ADDENDUM NO.: 3  
 DATE OF CMR ADDENDUM: 01.28.2013

**Notice of Construction Manager-at-Risk (CMR)  
 Addendum  
 on behalf of the  
 CT Department of Construction Services (CT DCS)**

<b>Project Name:</b>	<b>Southern Connecticut State University Buley Library Renovation</b>
<b>Project Location:</b>	<b>New Haven, CT</b>
<b>Project Description:</b>	<b>Core &amp; Shell &amp; Fit-Out</b>
<b>Project Construction Budget:</b>	<b>20.7 Million</b>
<b>CT DCS Project Number:</b>	<b>BI-RS-225B CMR</b>

**ADDENDUM NO. 3**

210. Reference: Drawing \_\_\_\_\_ Detail \_\_\_\_\_ Spec BP-06  
BP-09  
BP-09B

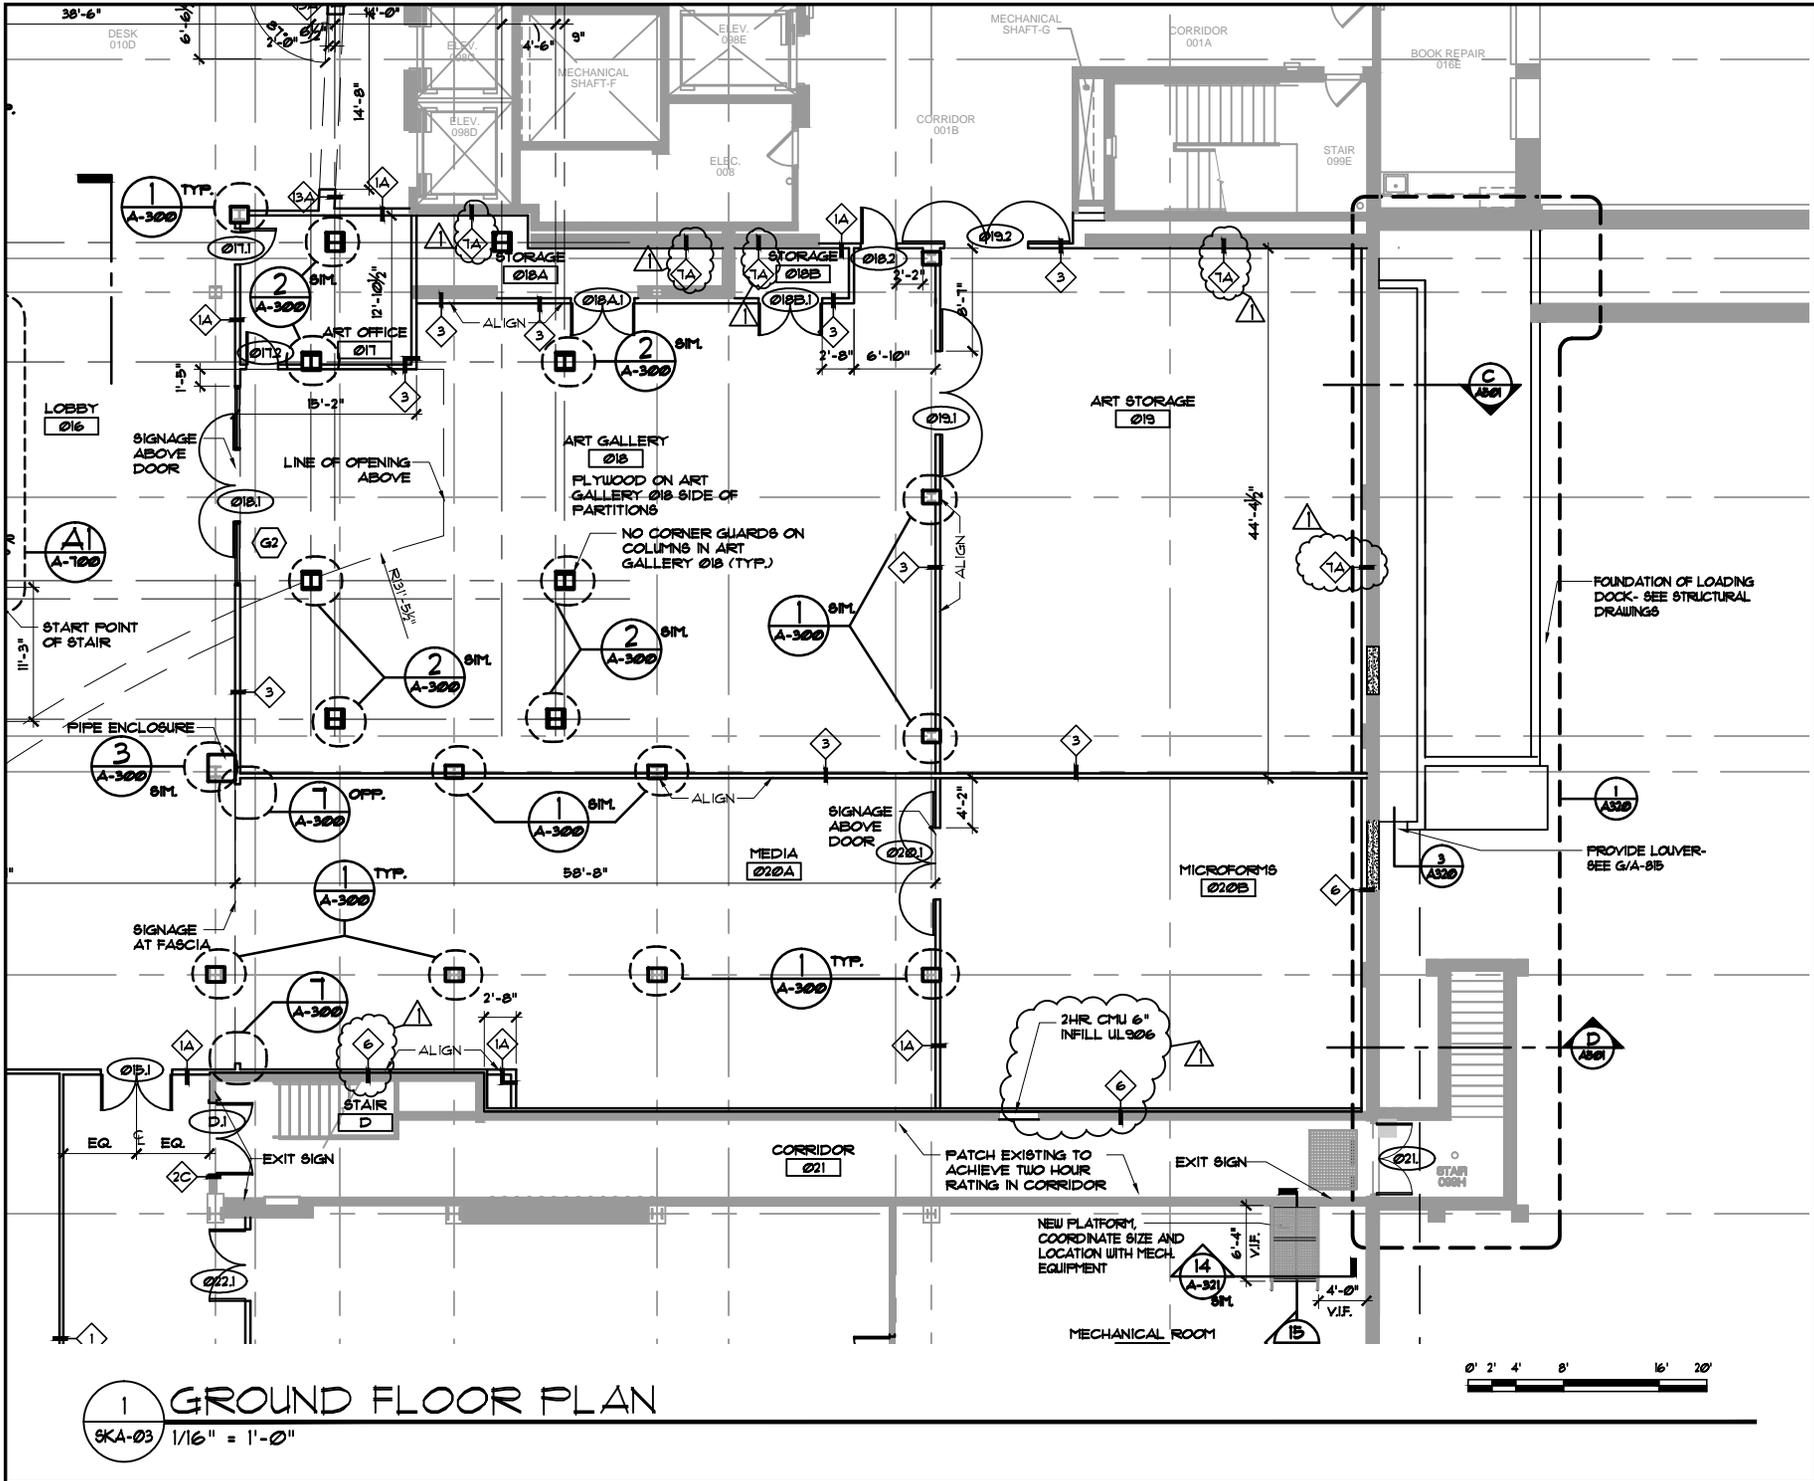
**QUESTION:** Addendum #2 RFI #134- Please clarify.

**SKANSKA RESPONSE:** Base bid for 2<sup>nd</sup>, 3<sup>rd</sup> and 4<sup>th</sup> floors includes gyp board prepared to receive wall finish. Base bid excludes paint and wall panels in non-room side (ie. south of column line XH, north of column line XK) and in lobbies.
